# **PLANNING & ZONING AGENDA ITEM #5**

***SUBJECT:*** Approval of a Site Plan for Dartmoor Retail Center II [53 – 95 NE Dartmoor Drive]

RE: Dartmoor Retail Center II

Per your request, staff and Veenstra and Kimm have reviewed the Site Plan for the Dartmoor Retail Center II located north of the Hickman Road/Dartmoor Drive intersection adjacent to Heartland Tire and Auto. Based upon our joint review, we have the following comments to offer regarding the site plan:

**DARTMOOR RETAIL CENTER II- GEOMETRIC PLAN**

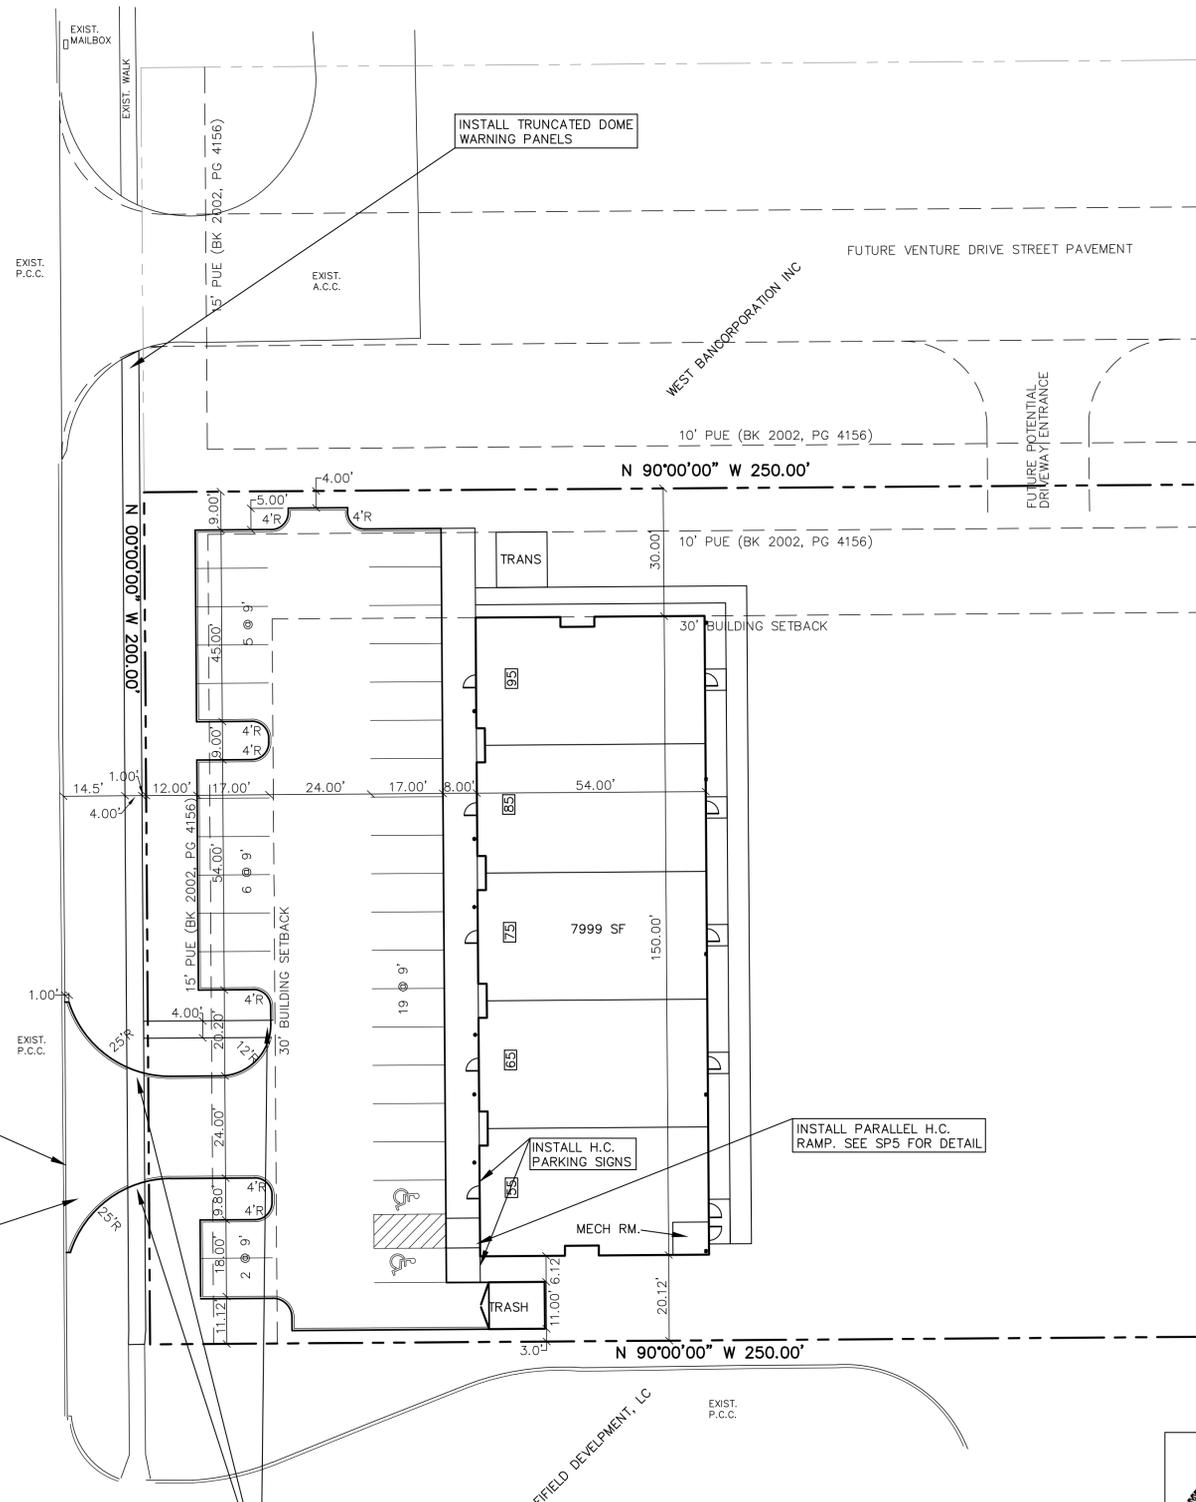
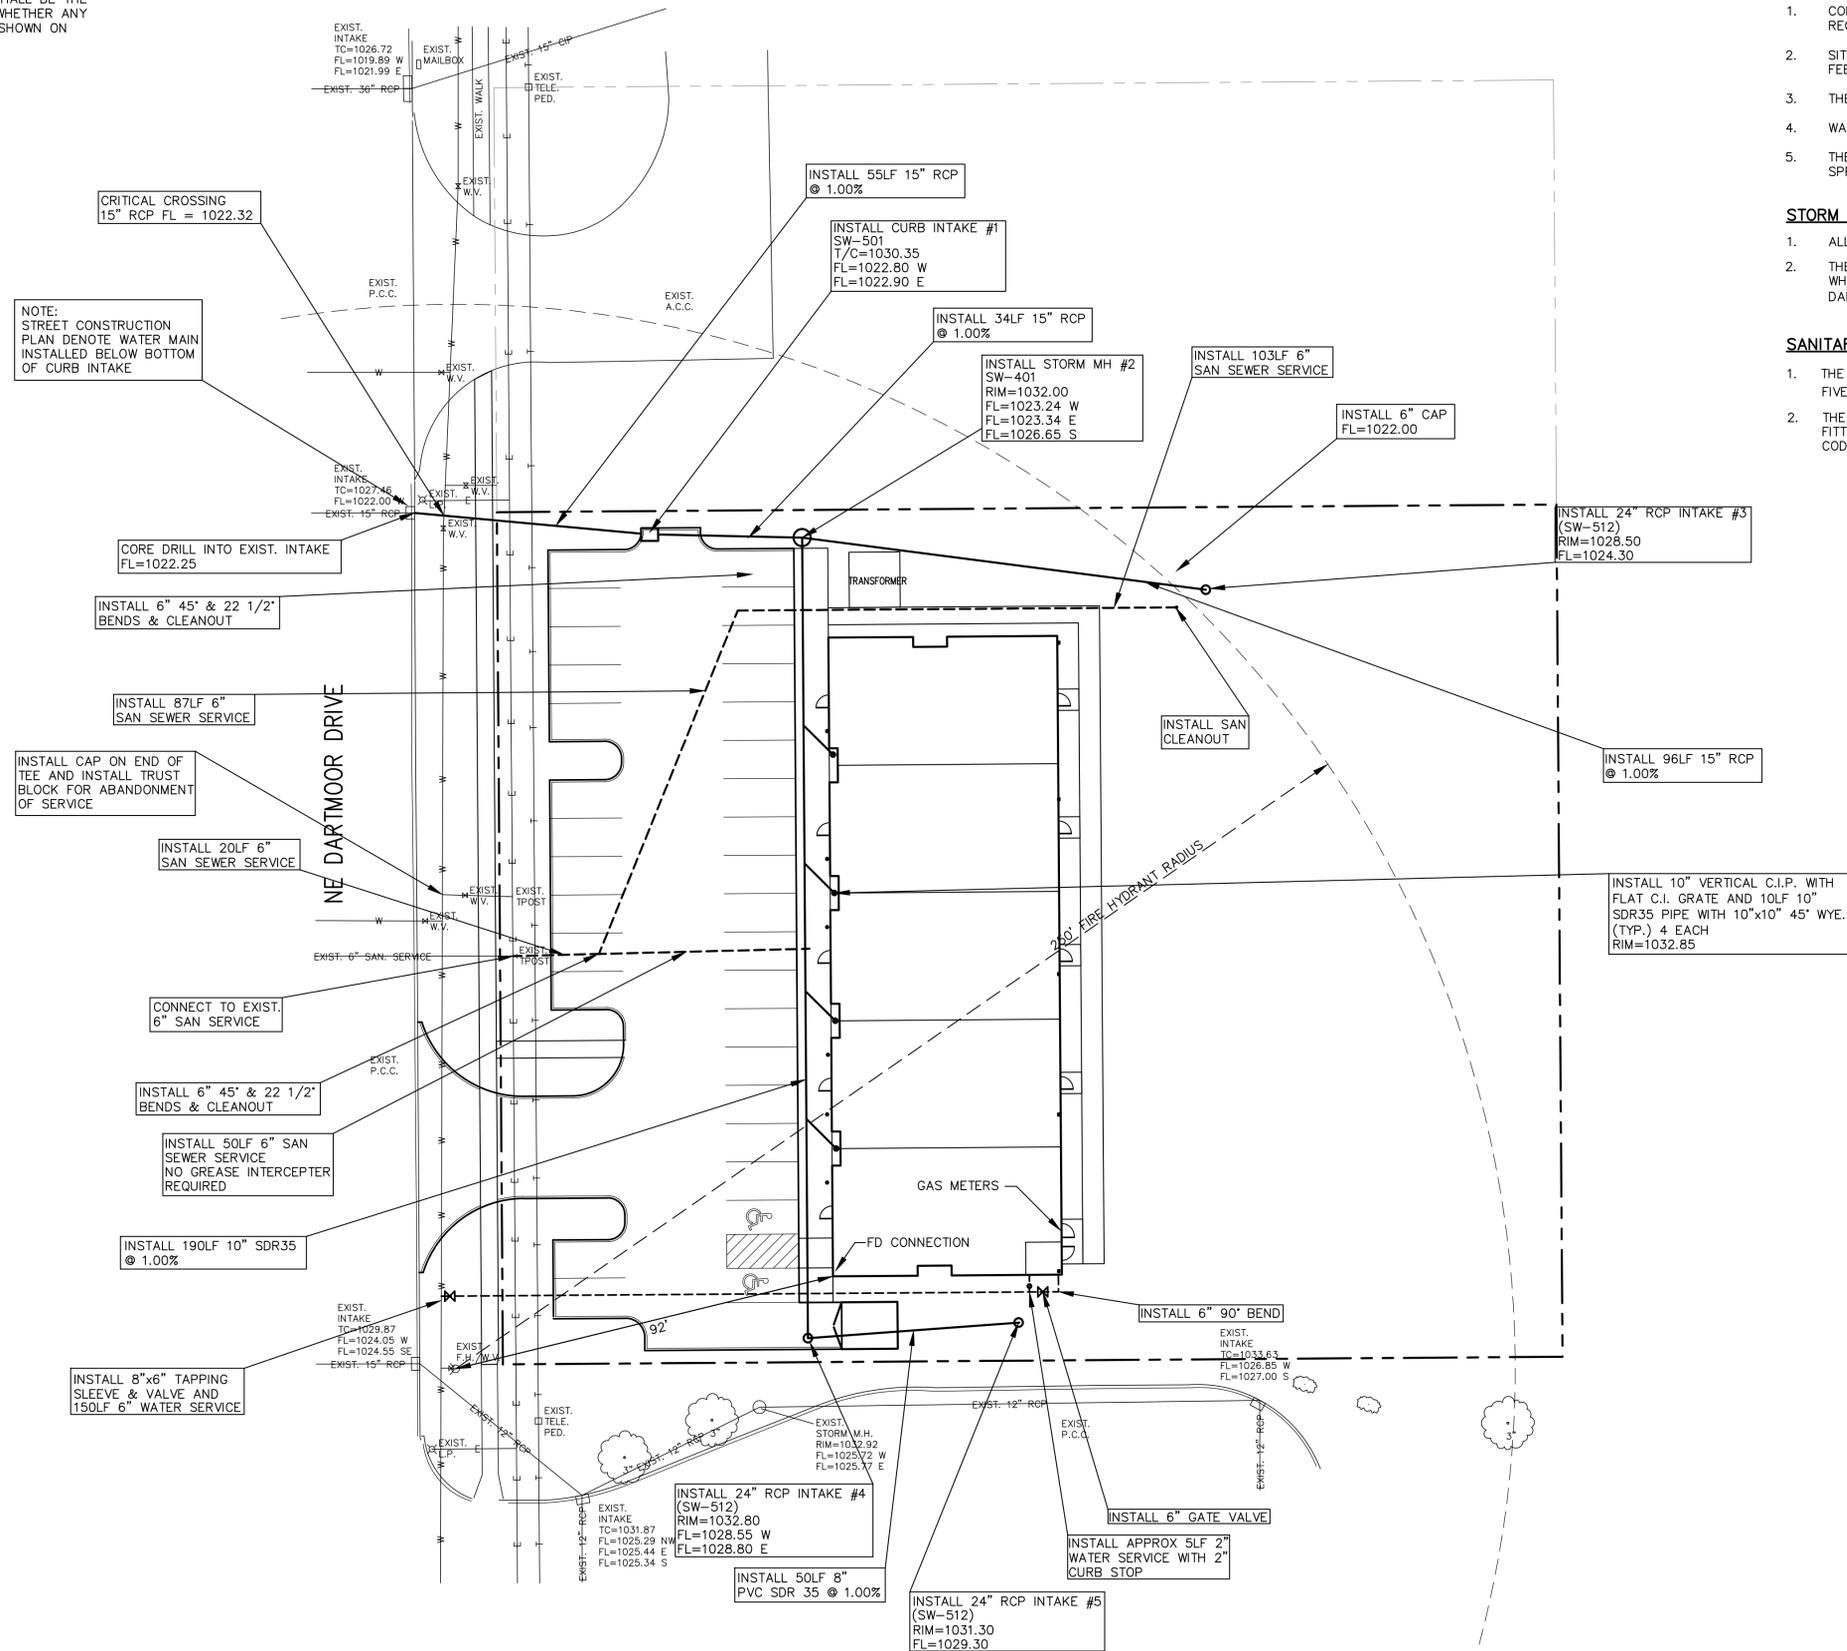
1. ~~The overall site address should be indicated as 53 NE Dartmoor Drive (Based upon the location of the common utility room in the southeast corner of the building).~~

2. ~~Anticipated dimising wall locations should be indicated on the plan set and addresses indicated for each tenant space. The addresses for the 5 tenant spaces should be indicated as follows: **The anticipated location of the dimising walls related to the common utility room should be indicated on the site plan.**~~

- ~~From south to north: 55, 65, 75, 85, 95 NE Dartmoor Drive~~
3. ~~Staff questions if the applicant intends on expanding the building at any time in the future or allowing for the leasing of proposed space to a higher parking user such as a restaurant. It may be beneficial to identify the location of a future phase or future parking stalls that could be added to facilitate additional space or higher traffic generation users. Additionally, staff would note that NE Venture Drive will be extended as a private drive in the future and may provide the ability to create a second access point into the site which may be beneficial. The most recent design of this private roadway has been attached for your use and reference. Please address. **Staff would like to meet and discuss the potential development of the private NE Venture Drive extension that would abut this project and how access, parking, and future expansion or future buildings may be located on the site. Staff would request that the applicant identify the planned roadway alignment previously provided for NE Venture Drive on the site plan in half tone. Please address.**~~

4. ~~The west side of NE Dartmoor Drive should be indicated on the plan set identifying the location of adjacent curb cuts/access and NE Venture Drive.~~

5. ~~**All existing easements should be indicated with recorded book and page. The existing 15 foot PUE on the west side of the property should be indicated on the plan set. Additionally, the 10 foot PUE on the north side of the property is part of an overall 20 foot PUE (10 ft on this property and 10 feet on the property to the north) which should be indicated on the site plan for clarity.**~~

6. ~~The dumpster will need to be relocated out of the front yard (defined by the location of the front elevation of the building) to comply with the ordinance provisions for its placement. Staff would suggest locating the enclosure on the south side of the building where the transformer is currently~~

shown and set the face of the enclosure back a few feet from the west face of the building. Additionally, the enclosure should be no less than 2 feet from the property line. Please address.

7. The note for Sudas Type A drive should be revised to indicate an expansion joint in lieu of the B joint.
8. The pervious and impervious surface calculations should be indicated on the plan set.
9. The adjacent property ownership should be indicated on the site plan.
10. ~~Truncated domes and warning panels should be indicated for all public sidewalk/private driveway crossings indicated on the plan set. Additionally, a truncated dome should be provided at the east end of the pedestrian connection from the public sidewalk into the site.~~

**DARTMOOR RETAIL CENTER II - UTILITY PLAN**

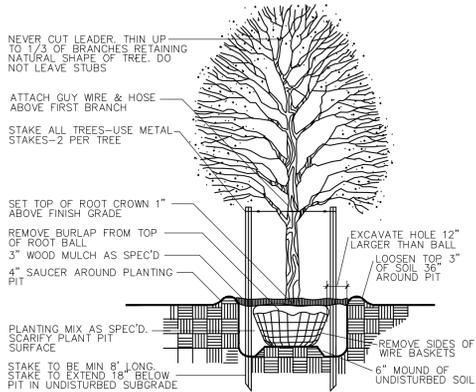
22. The critical crossing at the existing intake tie-in with top-of-water and bottom-of-storm-sewer elevation should be indicated on the plan set.

23. The existing 6-inch water service should be indicated with a note to have the tee capped and thrust block installed for removal/abandonment of the service.

24. A detail indicating the location of the fire and domestic water split should be indicated on the site plan. Additionally, valves should be indicated for both services prior to entering the building.

25. Verify that a hydrant is within 100 feet of the FDC on the building.
26. **A note should be added to the plan set indicating the required installation of a grease trap interceptor and confirmation of design and sizing to be provided from the WRA prior to issuance of a building permit of a food establishment.** Staff questions if an interceptor is intended to be sized for use by all potential tenants. The potential location of a grease trap interceptor should be indicated on the plan set for clarity. Please address.

27. A sanitary cleanout should be indicated at the end of the 6-inch sanitary service stubbed to the east of the building.
28. Verify the flowline elevation at Intake #3.

29. The types of storm structures proposed should be called out on the utility plan for clarity.
30. A note should be provided to core drill into the existing storm intake to create a smooth invert.

31. Staff questions what is being implemented to provide stormwater outlet rate control. Please address.
32. Staff questions if natural gas service is intended for the project. The location of any planned gas meters should be indicated on the plan set. Please address.

**DARTMOOR RETAIL CENTER II - LANDSCAPE PLAN**

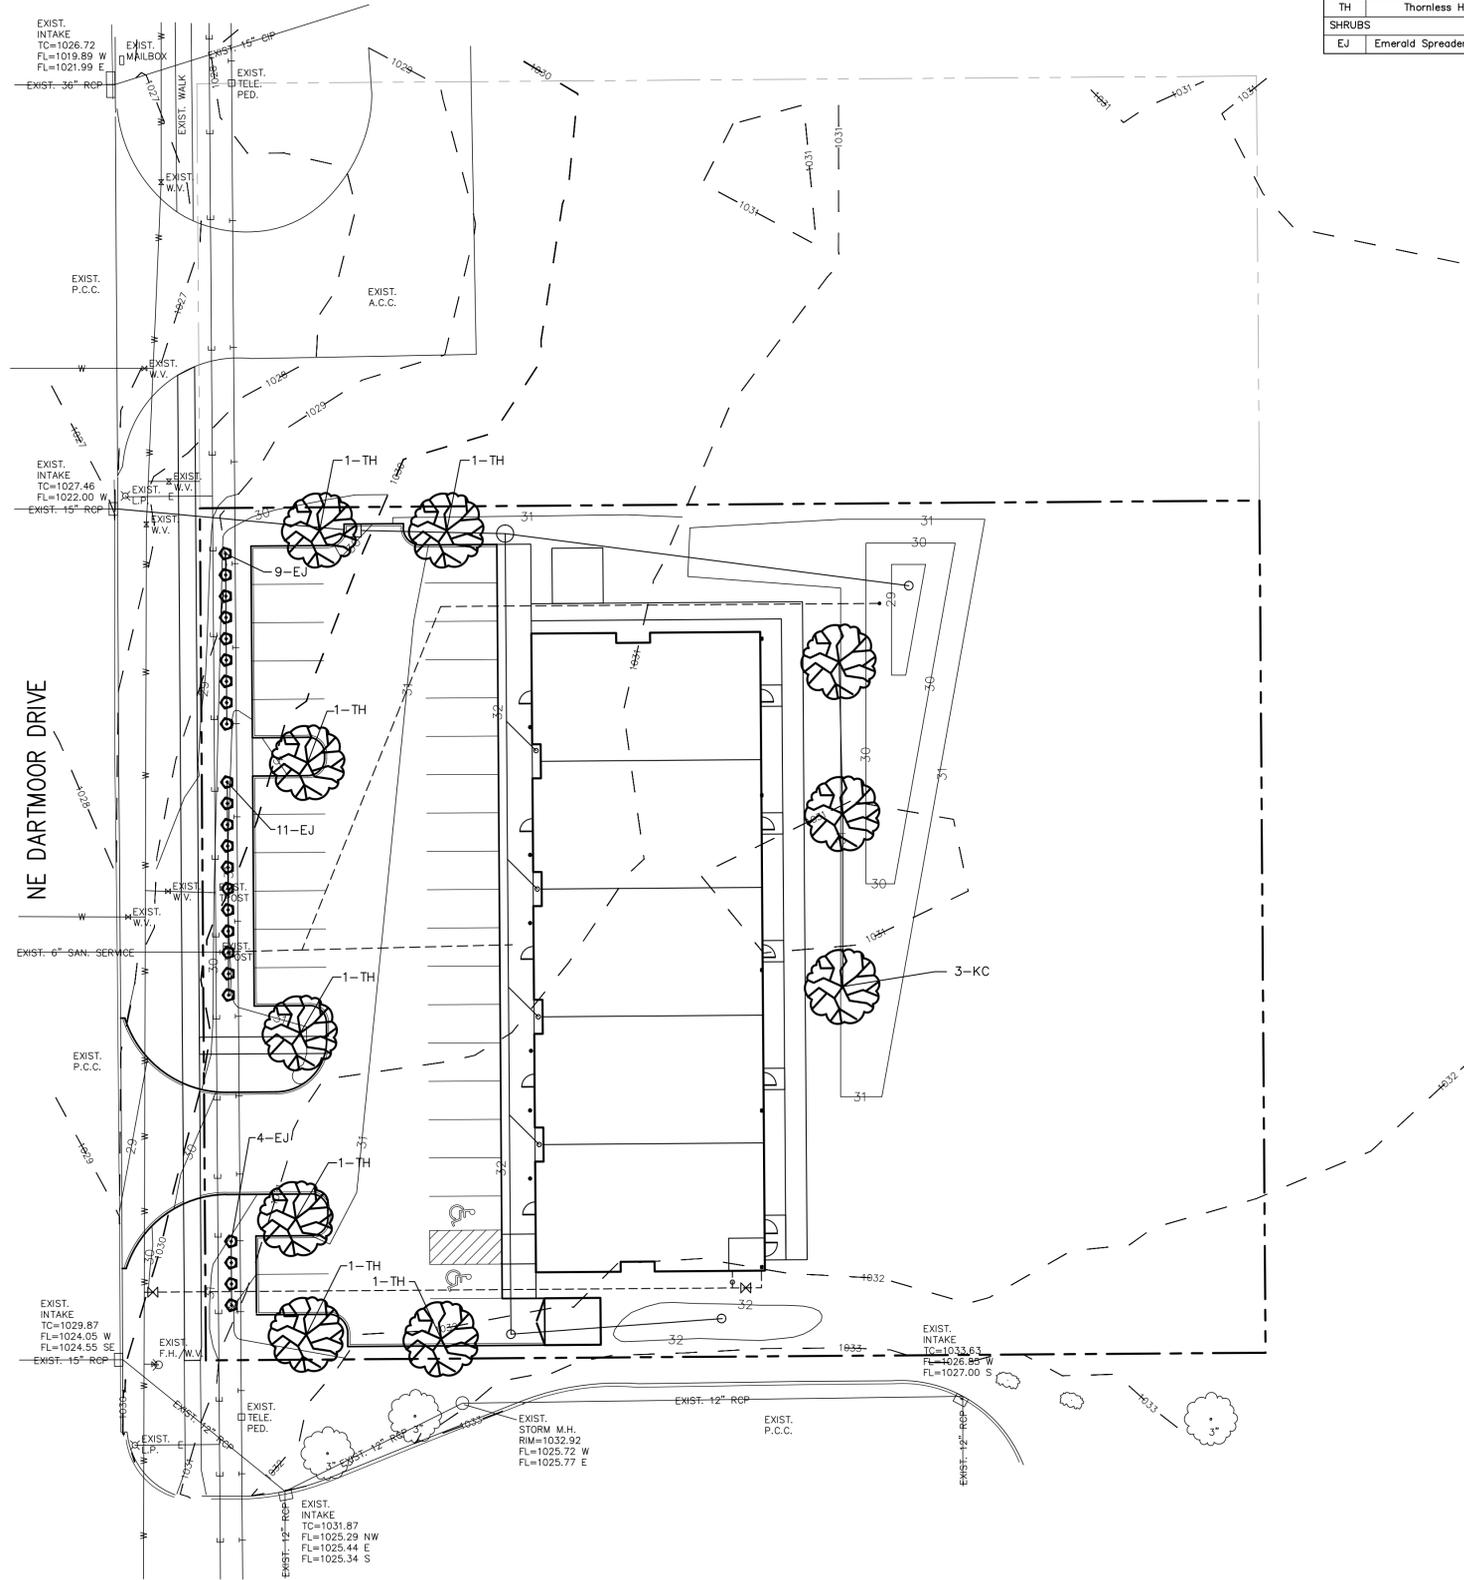
33. The landscaping requirement calculations should be revised and indicated as 1 tree per 1,000 square feet of required open space and 1 shrub per 1,000 square feet of required open space.

34. Additional plantings should be provided along the western edge of the site in the southwest corner of the site to adequately screen headlights facing NE Dartmoor Drive. Staff would request that shrubs used for this screening be a form of evergreen for year round satisfaction of the requirement.

35. Verify that there will not be any ground-mounted mechanical units and all mechanicals will be provided as rooftop units.
36. Verify that the transformer location does not need to be relocated due to the comments above related to the dumpster enclosure.

37. **A note should be added to the Landscaping Plan identifying any ground-mounted mechanical units, transformers, and utility meter clusters to be adequately screened from public view. The note should also specify that the screening plant species to be reviewed and approved by the Development Services Department prior to installation.**
